Access Compliance Report

Public Rights-of-Way

Intersection ID: 4530	Main Street: BROOKSHIRE_BV	Cross Street: MT_HOLLY-HUNTERSVILLE_RD	Location:	N
ADA ID: 7860568BF02B	Ramp Type: BlendTrans2	Initial Pass/Fail: Pass	Overall Compliance: No	Severity Score: 0
Codes/Mitigation Info/Possible Solution		Field Measurements/Component Compliance

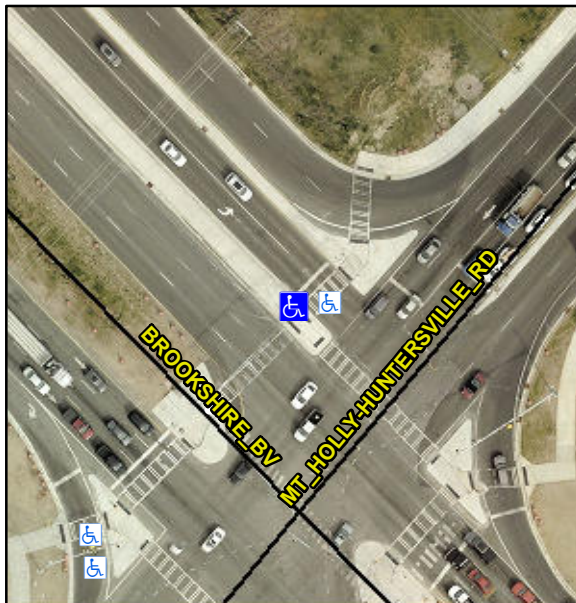
Remove & Replace Curb Ramp With Two New Directional Ramps or Equivalent.

R304.2.3, R305.2
